Meeting of the
Scotts Valley Planning Commission
In-Person and Remote Access
Date: January 25, 2024
Time: 6:00 PM

1. Consideration of a Negative Declaration, General Plan Amendment, Zone Change, Planned Development Zoning application, Design Review application, Use Permit application and Cultural Resources Alteration application to allow for the construction of a 52,822 sf three story commercial development on a 1.35 acre site located at 125 Bethany Drive (APN 023-102-15). Proposed land uses would include 10,465 sf of professional and administrative office space, and 42,357 sf of storage for up to 227 users.

1 SITE PLAN
Scale: 1/16" = 1'-0"

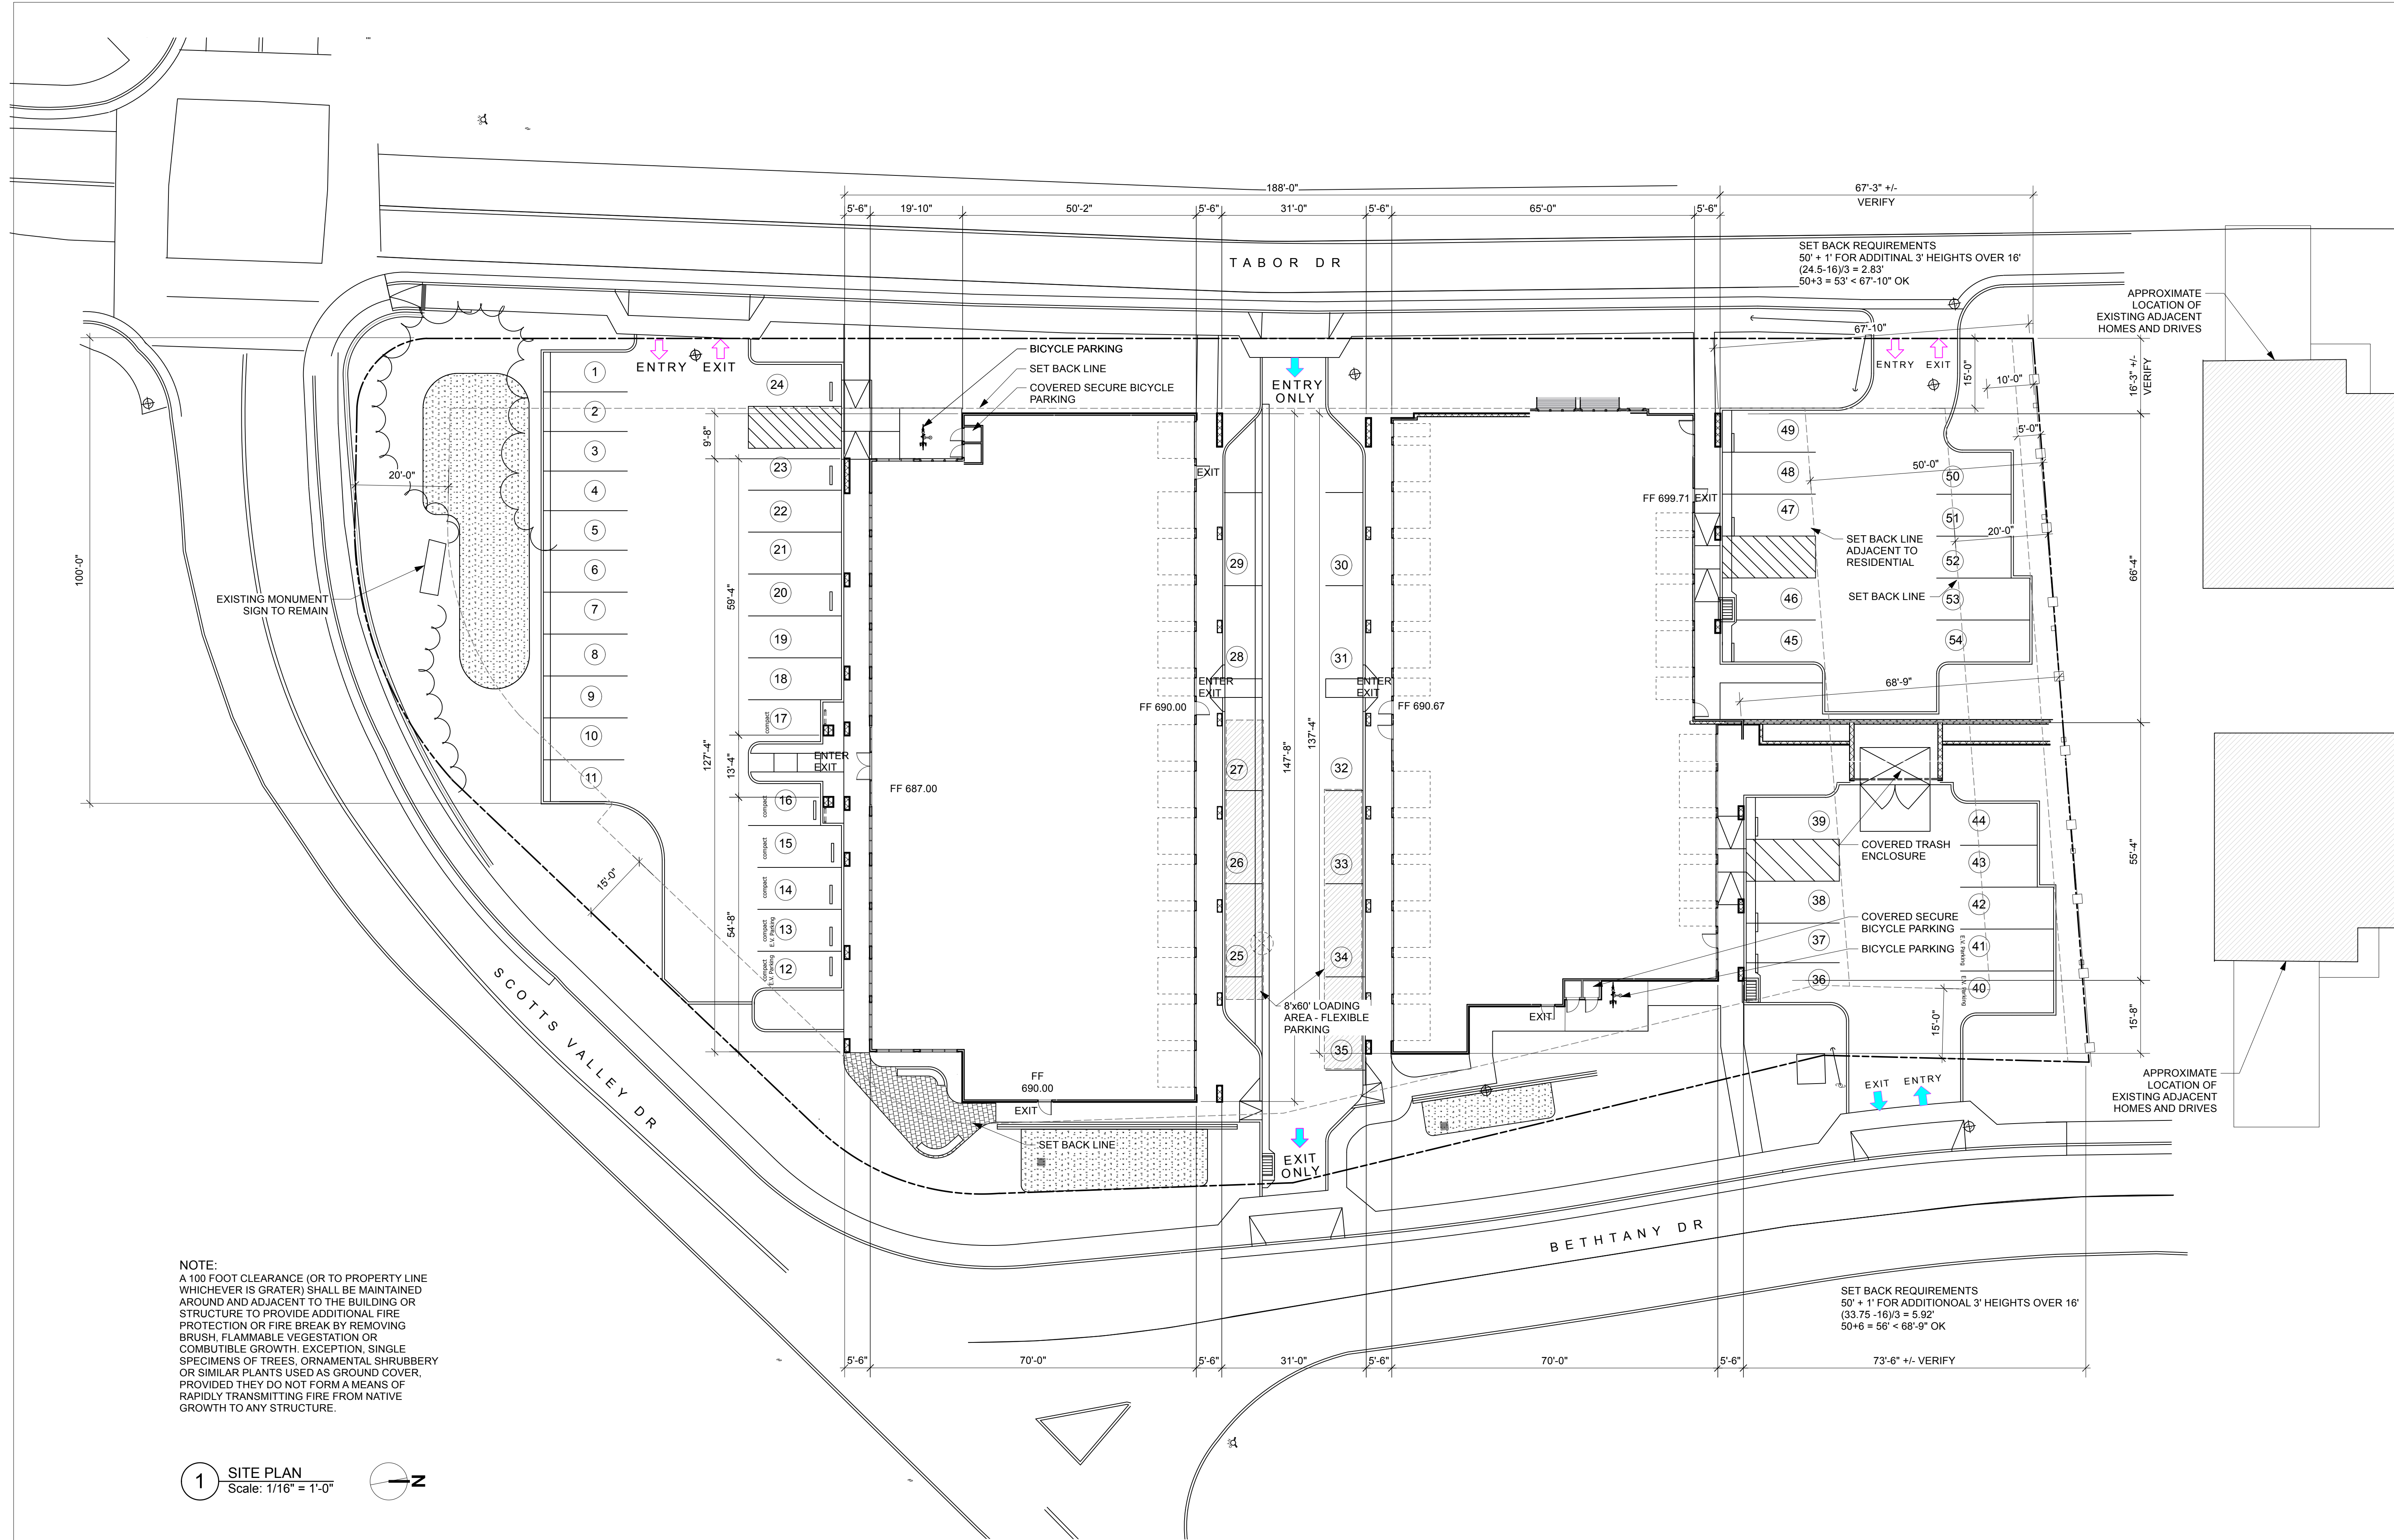
The trash enclosure is located to the rear of the site, within the parking lot, and adjacent to the residential, as shown on Attachment 1: Site Plan, Sheet A2.1.

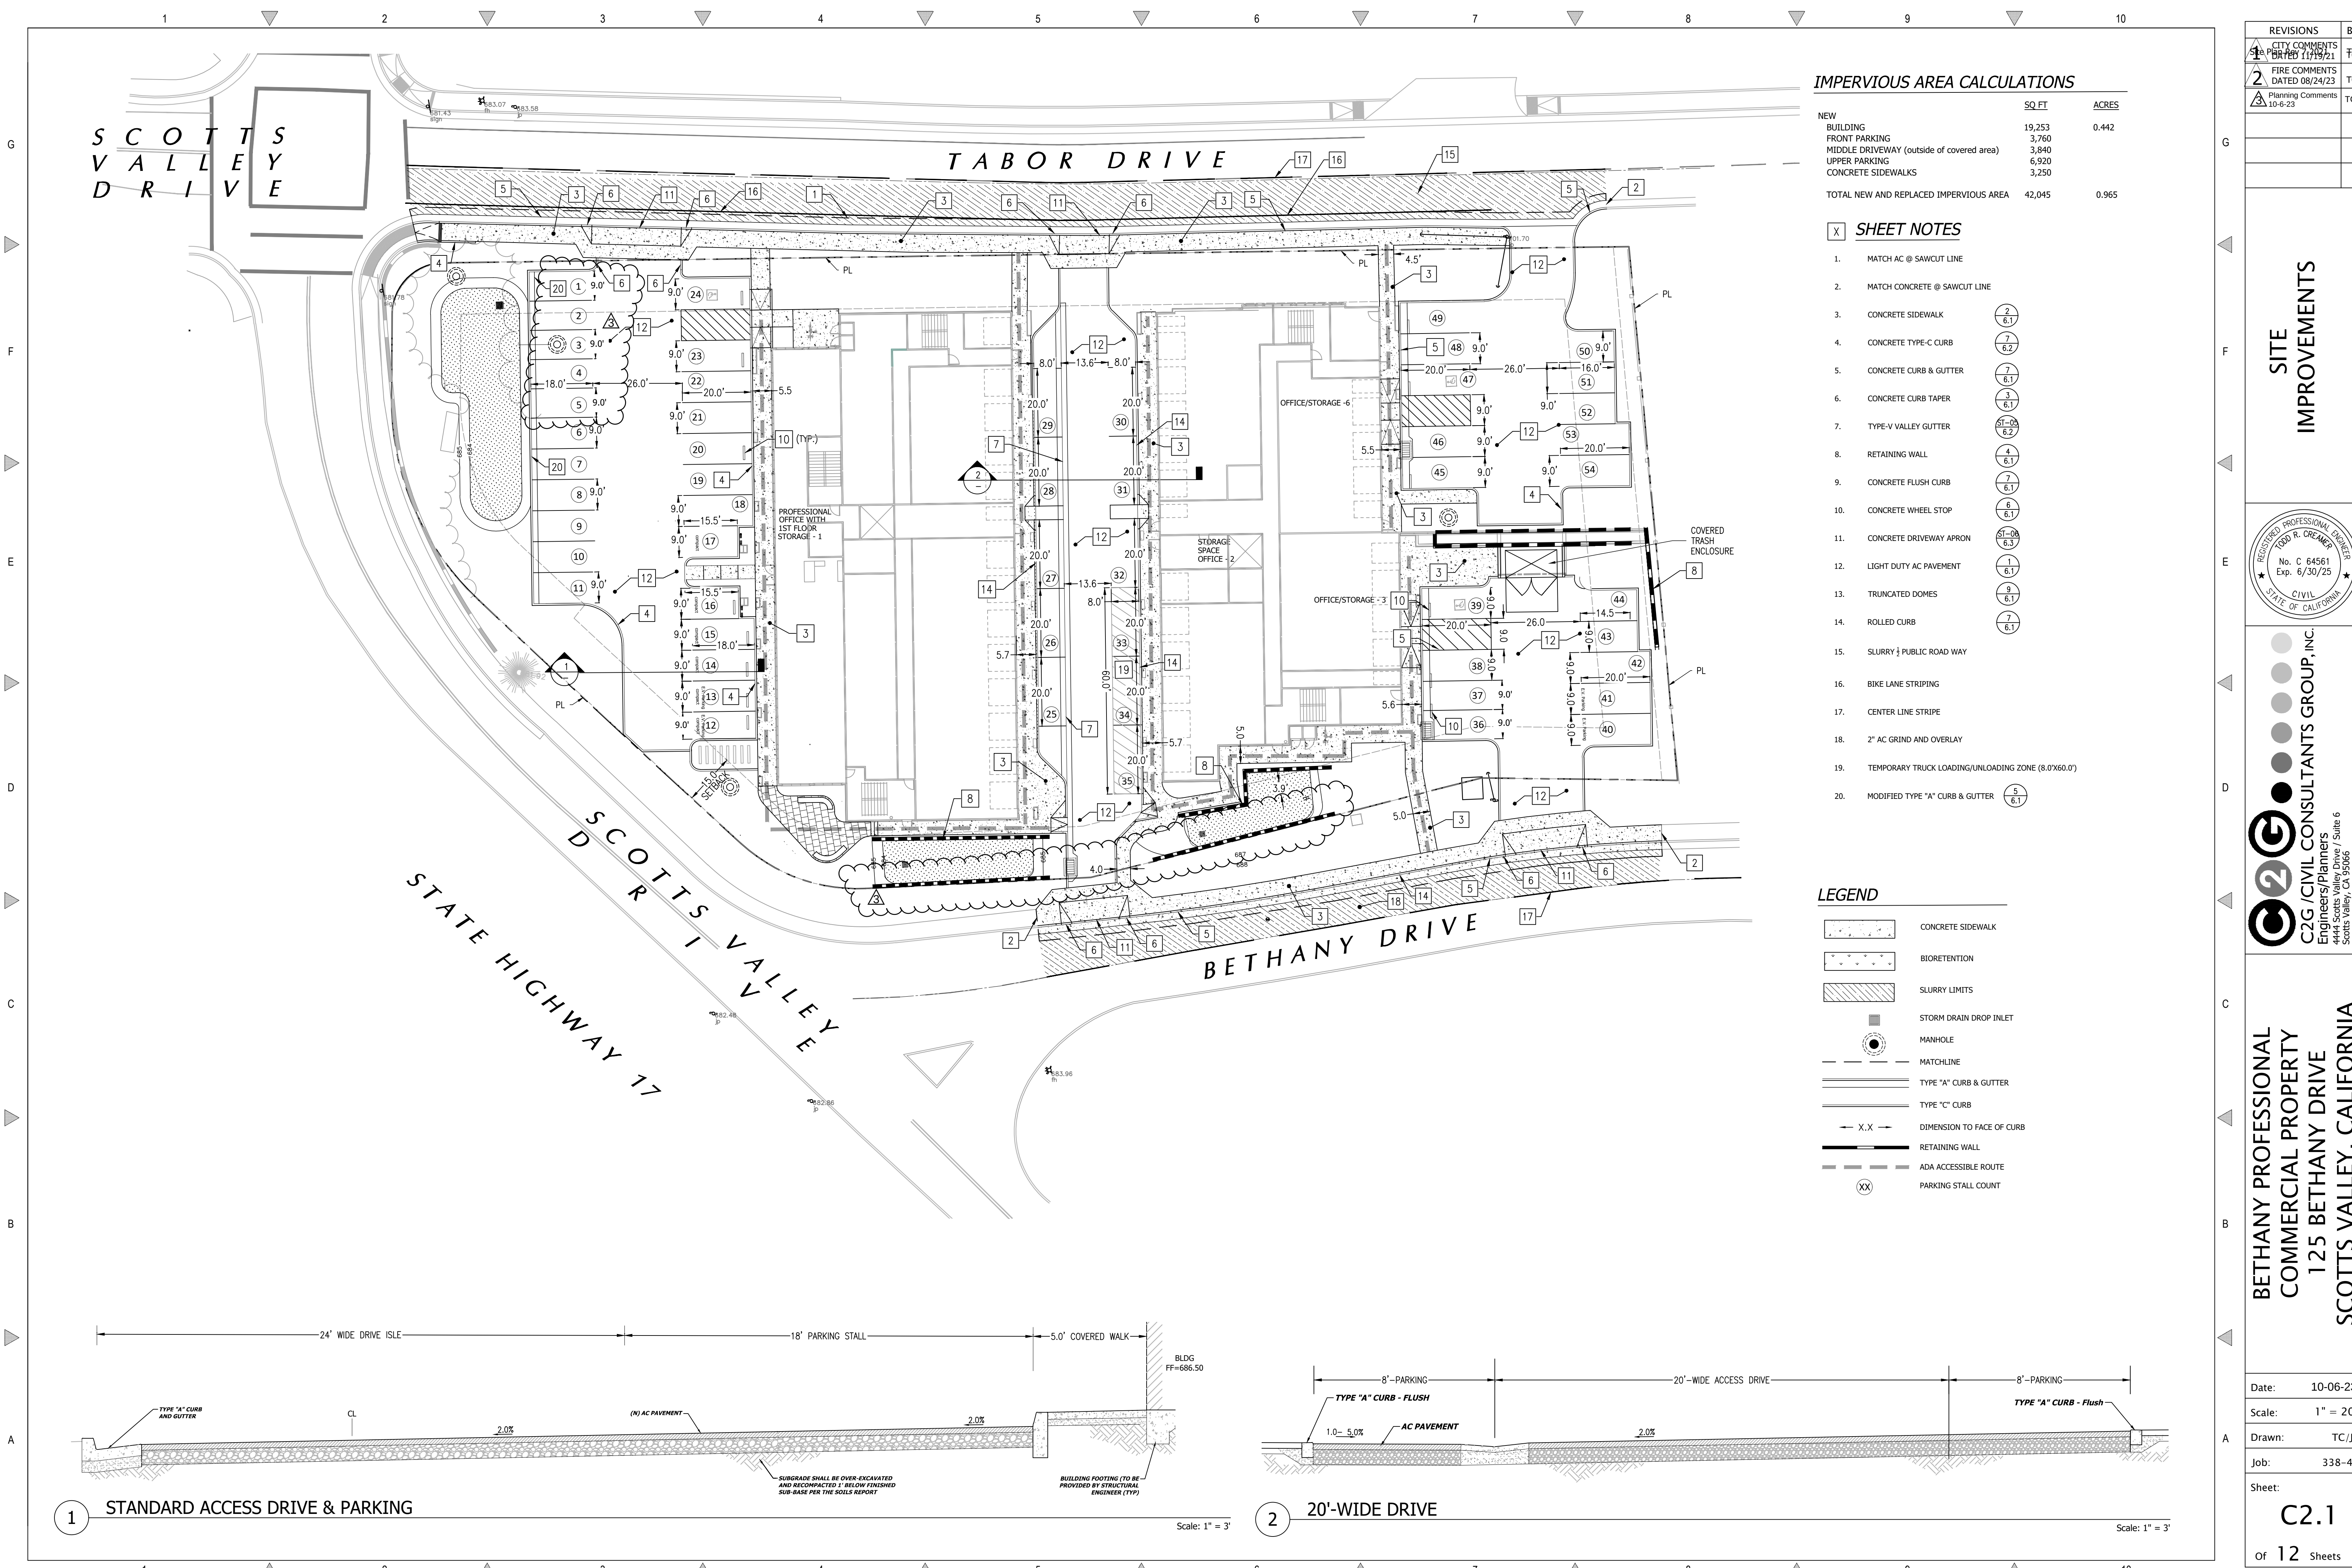
The Planning Department has concerns about the size of some of the parking spaces as well as the overall parking lot design in the rear lot. As shown on Attachment 1: Sheet C2.1 of the plan set, many of the proposed parking spaces do not meet these requirements and many of the parking spaces do not include dimensions to demonstrate compliance. In addition, all of the spaces along the access drive that runs through the building are undersized, measuring only 8' in width.

In addition to the undersized parking spaces, the Planning Department also has concerns about the parking lot design. As shown on Attachment 1: Sheet C2.1 of the plan set, and mentioned previously, parking spaces 39 and 44 would be difficult to maneuver in and out of as the trash enclosure does not allow for adequate turning movements or back up space.

As shown on Attachment 1: Sheet C2.1 of the plan set, the proposed project includes a loading zone located within the internal drive aisle. The drive aisle is 13.6' wide and includes eleven 8' x 20' parking spaces on both sides.

The Planning Department has several concerns about the loading zone. First, Attachment 1: Sheet C2.1 Site Improvements, shows the proposed loading space to be 8'x60', which does not satisfy the Zoning Code requirement of two 12'x45' spaces. Second, when the loading zone is in use, it blocks parking spaces limiting the amount of required parking on site. Third, if the parking spaces were in use when a truck needed to use the loading space, the truck could potentially park in the drive aisle, and this could create queuing problems on and potentially off site. Finally, if a large truck were parked in the loading zone, and the parking spaces on the opposite side were in use, the drive aisle could potentially be blocked, which could also create a queuing problem.

REVISIONS		BY
1	Planning Comments	TC
10-6-23		
LIGHTING PLAN		
BETHANY PROFESSIONAL PROP. 125 BETHANT DRIVE SCOTT'S VALLEY, CALIFORNIA		
Date:	10-06-23	
	1" = 20'	
Drawn:	TC/JB	
Job:	338-40	
Sheet:	E1	
Of	1	Sheets

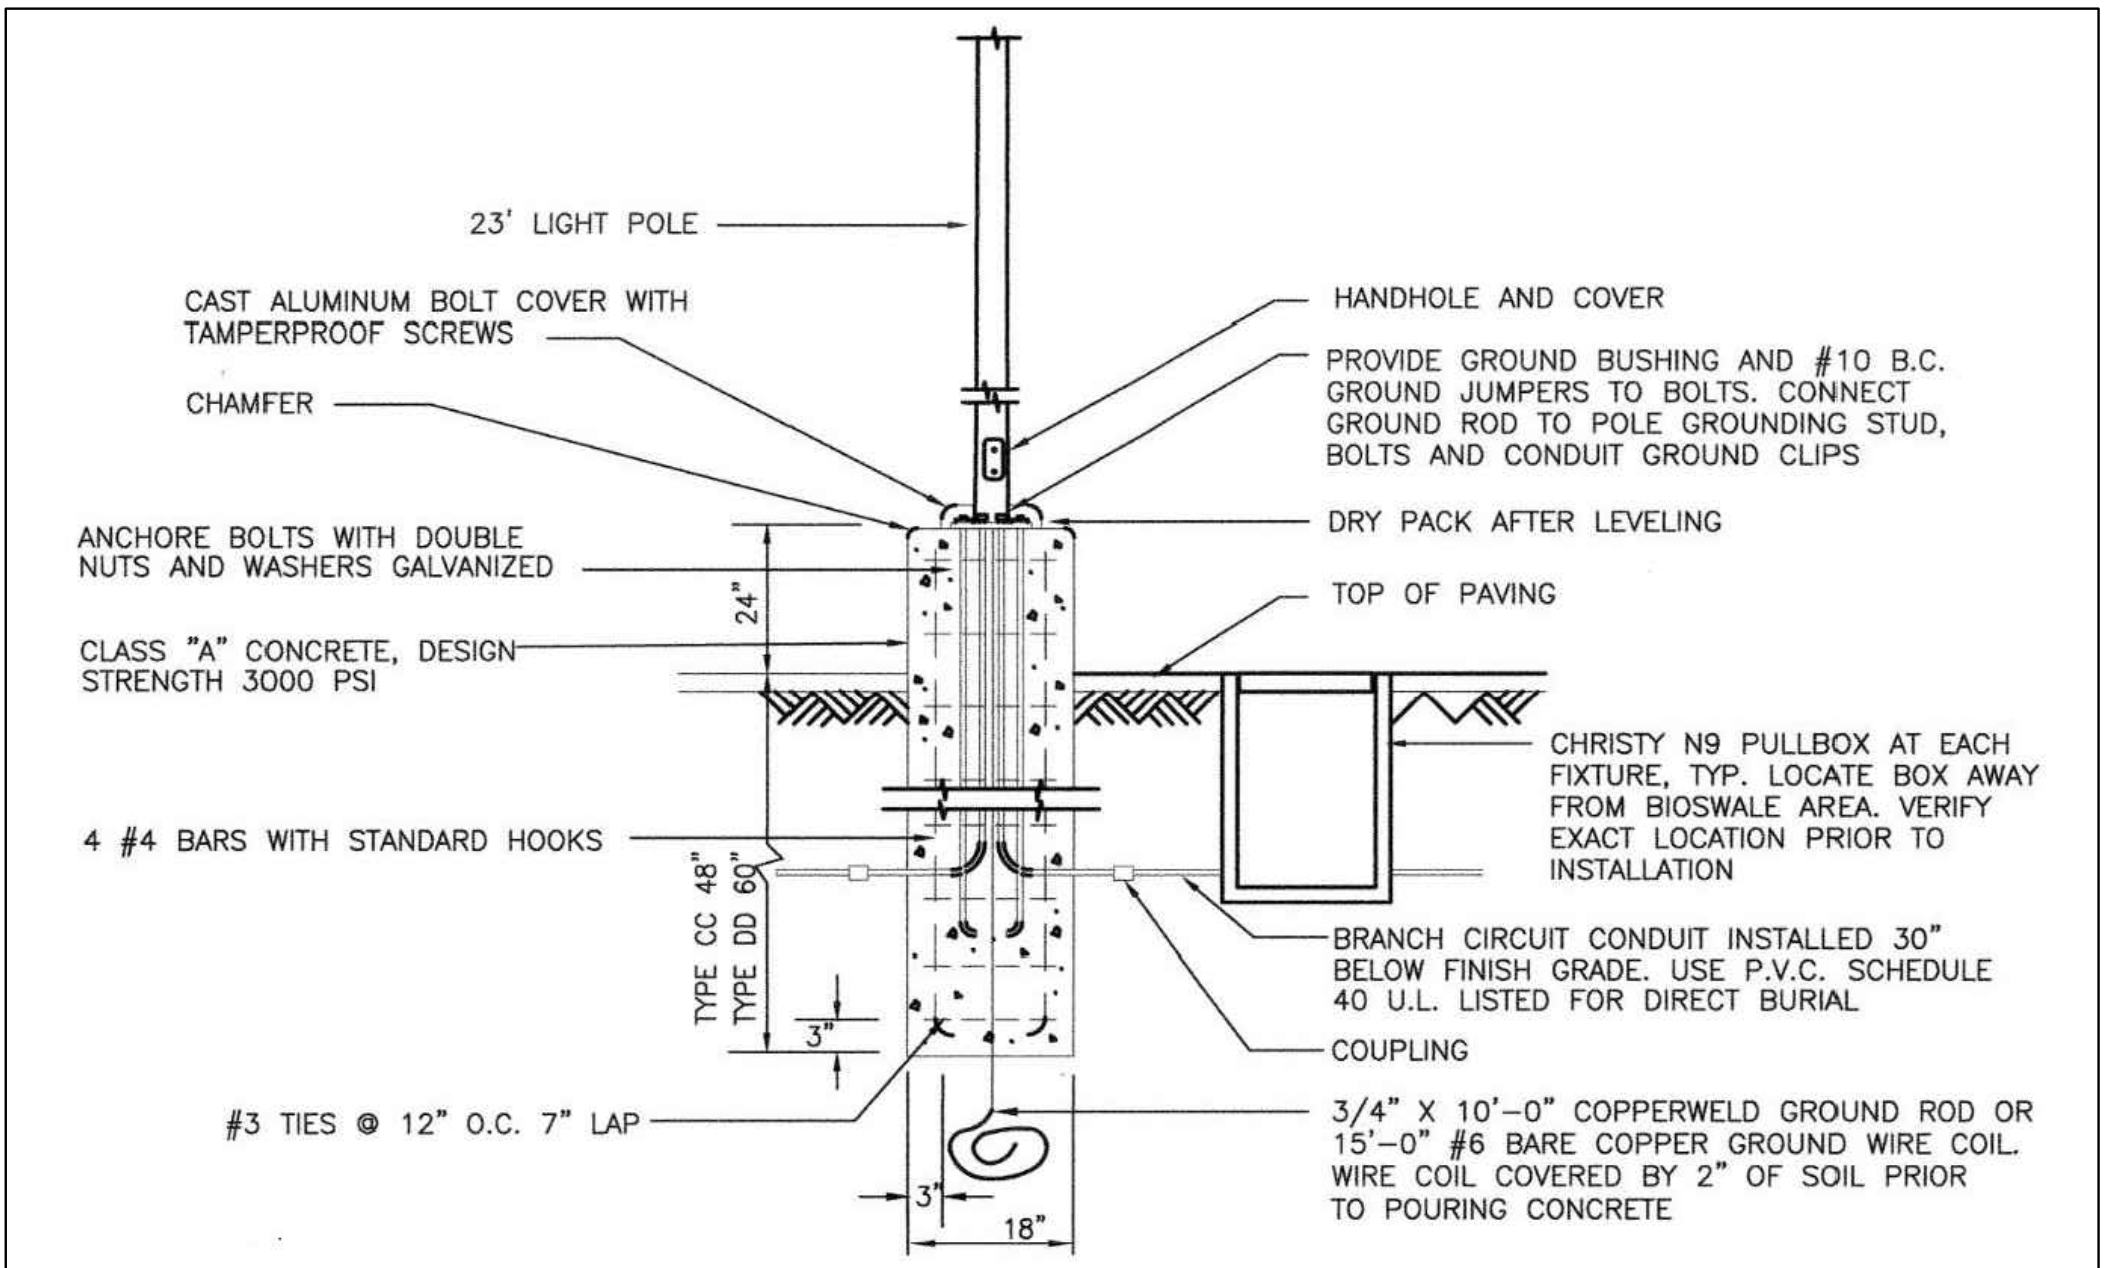
The Planning Department has concerns about one of the free-standing light fixtures located at the rear of the project site, adjacent to the residential uses where the photometric plan shows light leak to the adjacent property (Attachment 1: Sheet E1). If approved, the project would include a condition of approval that would require all lighting footprints to be fully contained on site.
